Docket No. 50-220

RE: SCHEDULE FOR THE IMPLEMENTATION AND RESOLUTION OF THE MARK I CONTAINMENT LONG TERM PROGRAM

EVALUATION BY THE  
OFFICE OF NUCLEAR REACTOR REGULATION  
OF  
SUPPRESSION POOL  
TEMPERATURE LIMITS  
IN BWR FACILITIES

Figure 1 TYPICAL SRV DISCHARGE DEVICES

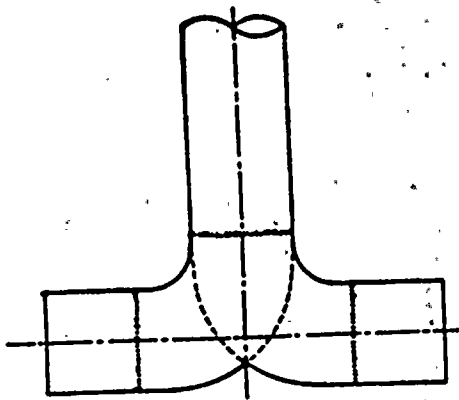
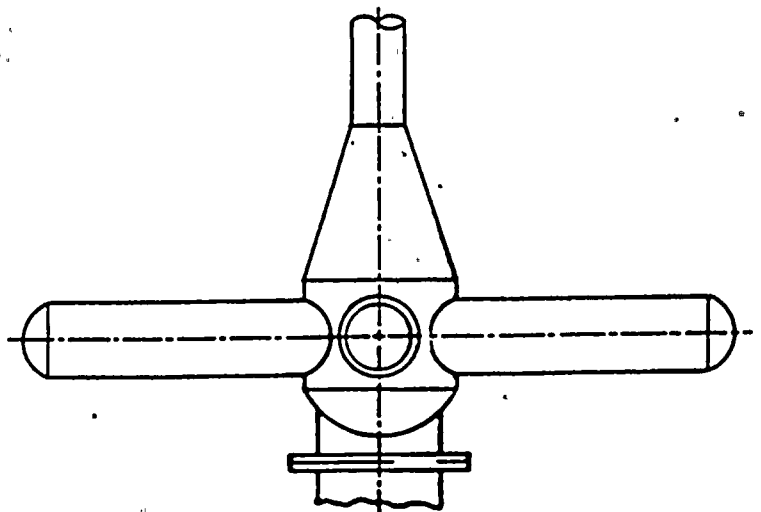
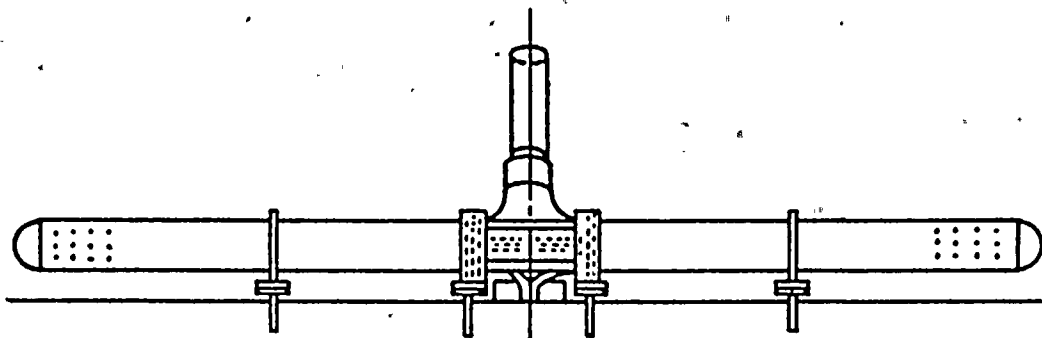
Safety-relief valves (SRVs) in BWR plants are used for reactor vessel pressure relief during either anticipated plant transients or accident situations. These valves are installed on the main steam lines of the reactor system with discharge lines from the valves routed to the suppression pool. When the valves open, the steam is discharged through the piping into the pool where it is condensed. A discharge device, which is affixed to the end of the piping beneath the water level in the pool, serves to mix the discharged air and steam with the pool water. The most common discharge device in use today is the ramshead type, which consists of two 90-degree pipe elbows welded together, as shown in Figure 1.

Figure 1 shows the configuration of a typical cross quencher, which is currently used by all Mark III containments. The cross quencher has four arms with each arm perforated by several rows of small holes. The tip of each arm is plugged and the device measures approximately 10 feet long from tip to tip. Steam flows through the hub, is distributed among the four arms, and is discharged into the pool. The T-quencher device presently being developed for the Mark I plants is similar to the cross quencher except that it has only two arms that are approximately 20 feet long from tip to tip. The quencher device produces a cloud of air or steam mist, whereas the ramshead produces large bubbles.

Based on the improved performance demonstrated for the quencher discharge devices and the uncertainty associated with the definition of the pool temperature limits for ramshead discharge devices, we conclude that the use of ramshead devices in BWR water suppression containment systems is not acceptable for long-term operation. We also conclude that the quencher-type devices provide a satisfactory resolution to the condensation stability concerns and is, therefore, an acceptable replacement.

Figure 2 PLANT OPERATIONAL EXPERIENCE

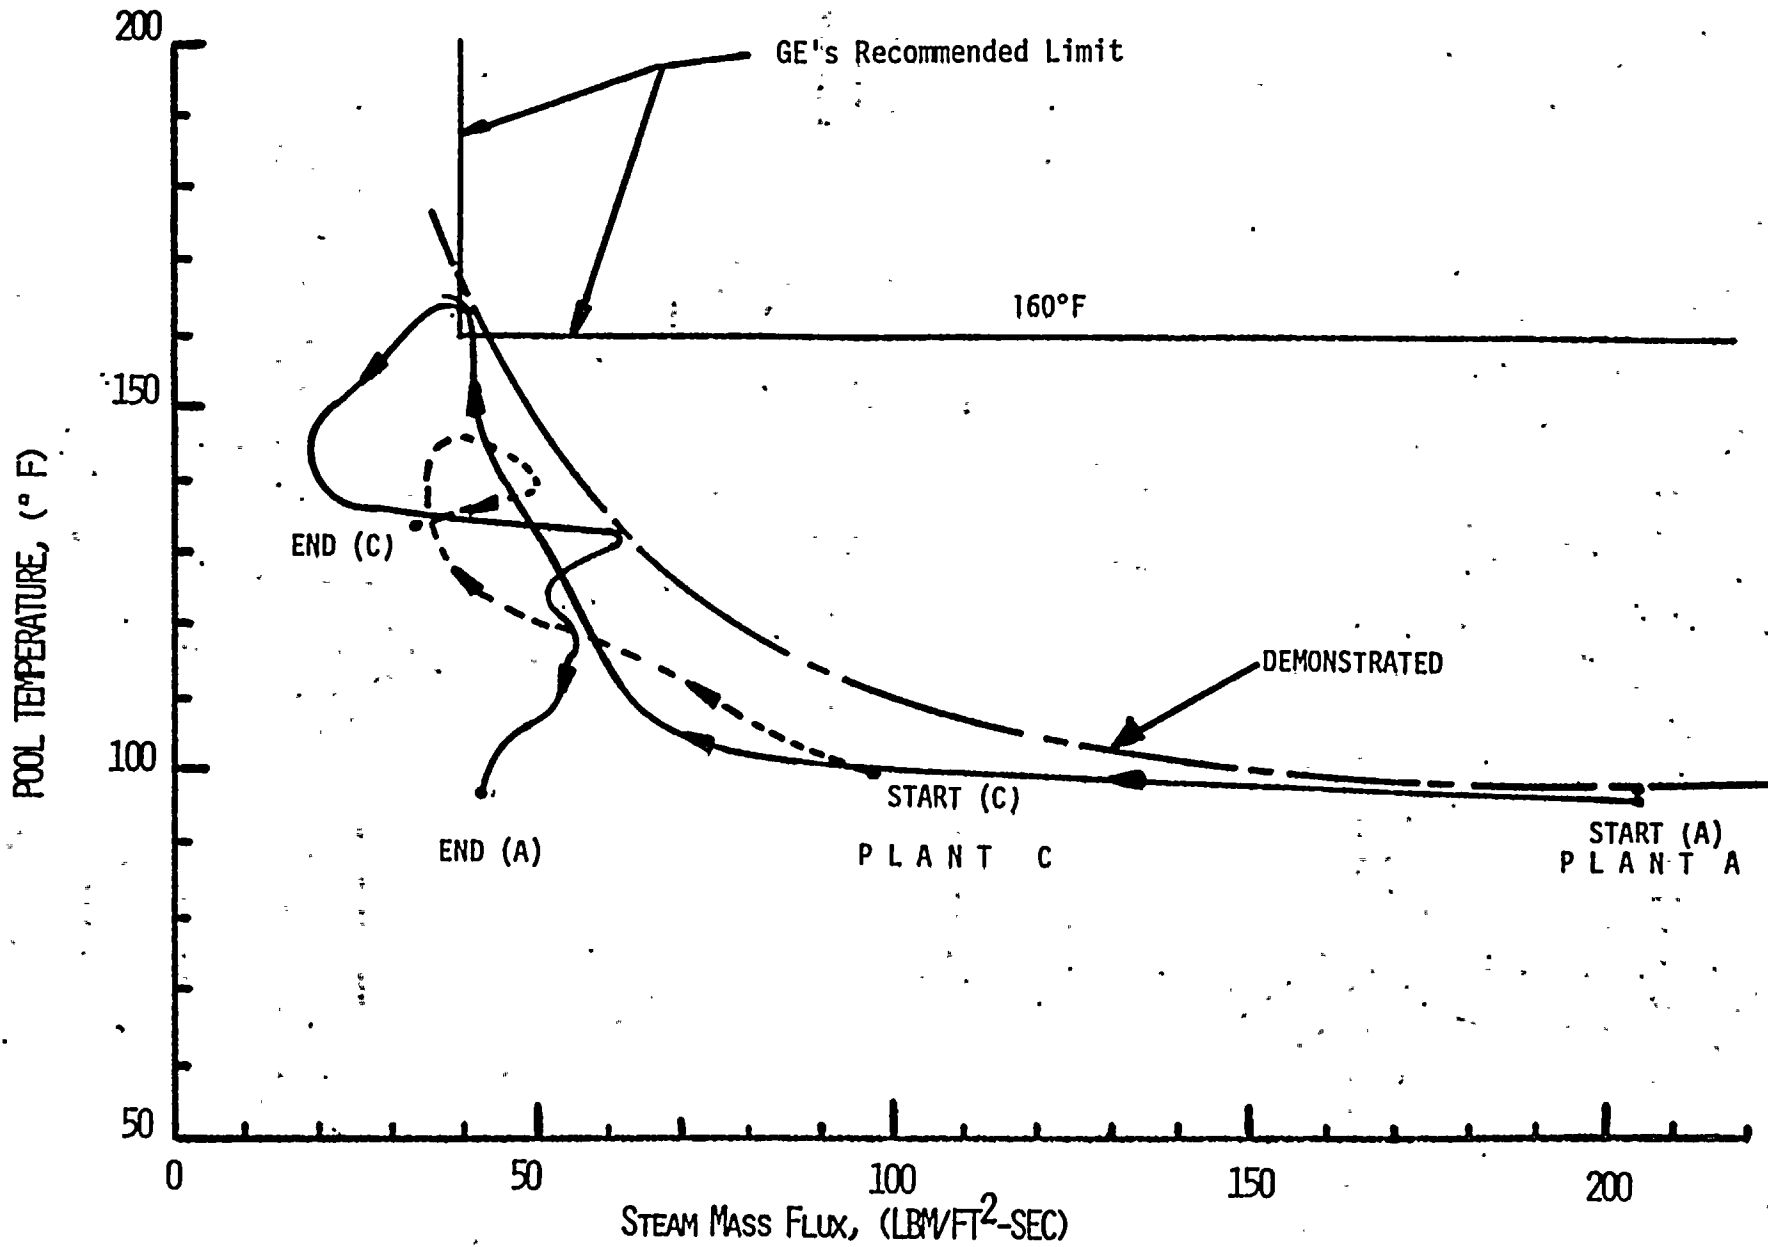
Figure 2 shows the loci of the Plant A and C events on a plot of pool temperature versus SRV steam mass flux during blowdown. It also shows the GE-proposed pool temperature limit. It is clear that the plants experience SRV discharges far below the GE proposed pool temperature limit at virtually all mass fluxes except the lowest. Thus, their experience does not provide support for the higher mass flux at the GE-proposed limit of 160°F.

Figure 3 MARK III STANDARD PLANT SRV WALL PRESSURES

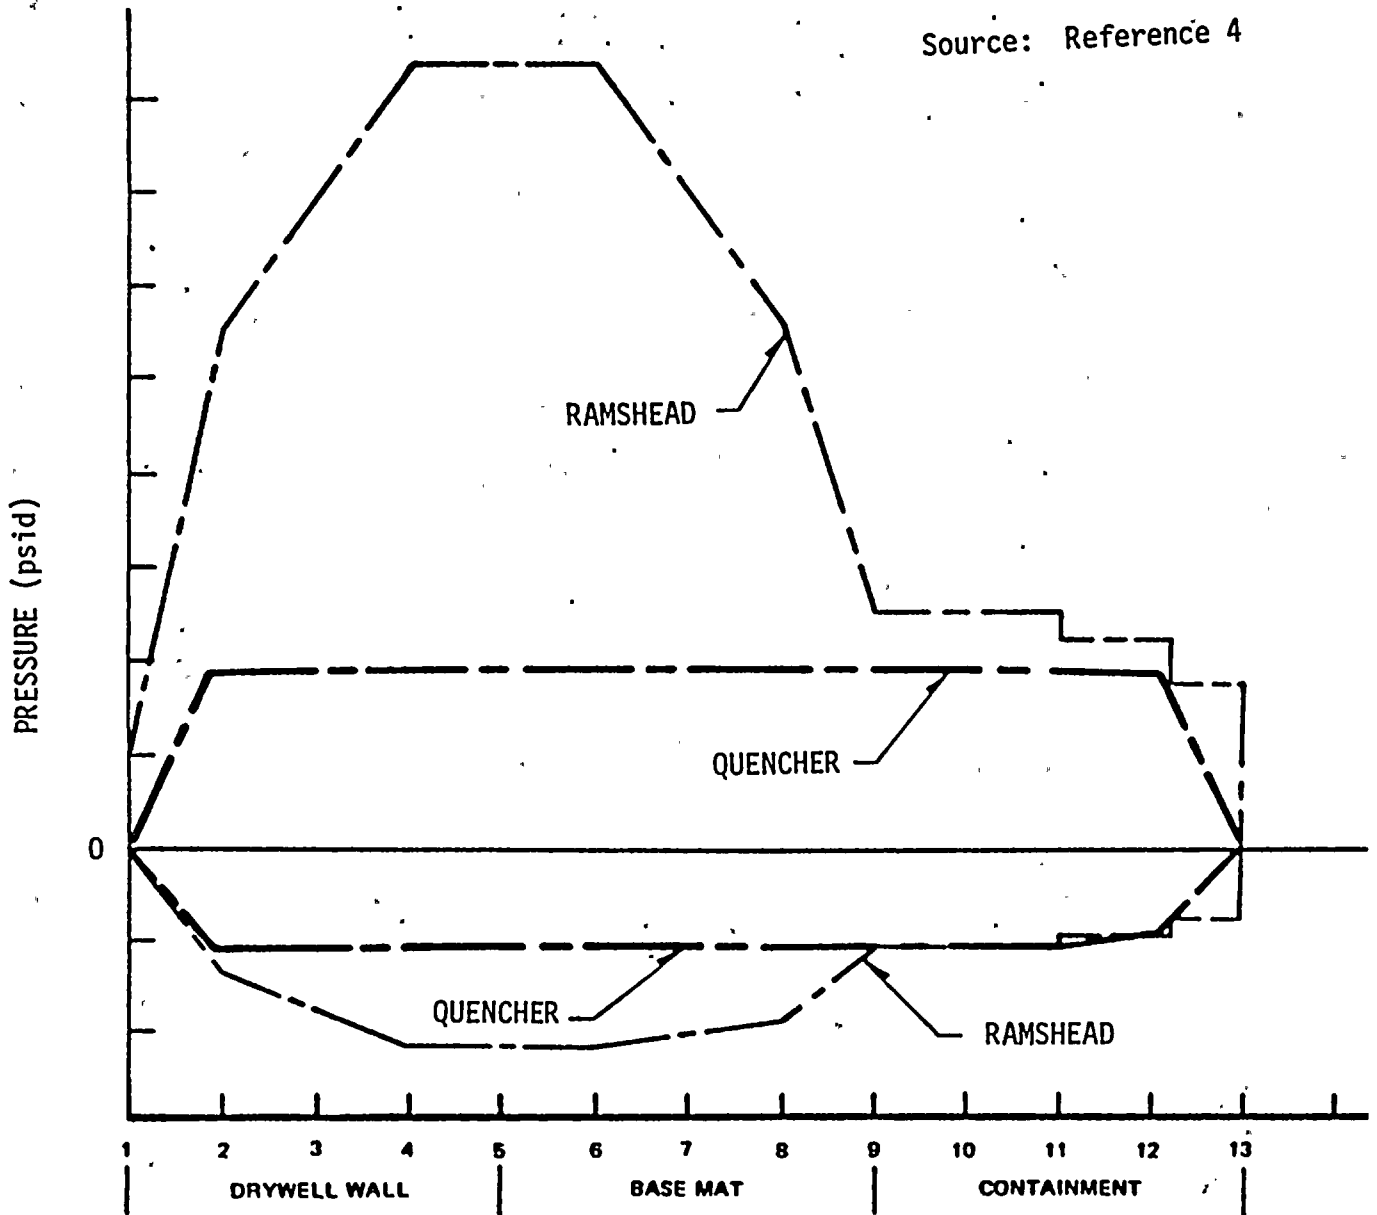
Figure 3 shows the comparison of structural loading functions for quencher and ramshead devices for a 238 GESSAR Mark III plant. Although these loading functions are not applicable for the Mark I design, they demonstrate that the quencher device, in general, substantially reduces the loads on the containment structure with the magnitude of the load reduction being dependent on the quencher configuration and its relative location to the adjacent structures.
